## Product / Process Change Notification (PCN)

**PCN #:** PCN\_SwTASU\_20210430

**Affected Series:** 434 35x 045 816, 434 33x 045 822  
 436 35x 045 816, 436 33x 045 822

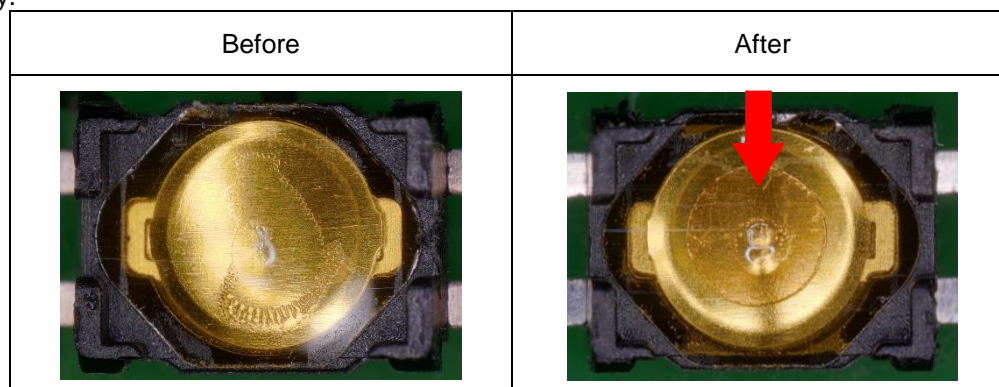
In order to enhance the product reliability, Würth Elektronik will change the process at assembly station and improve the product design.

The additional mylar to be added between Dome and top mylar. With double mylar, the product is enhanced its reliability.
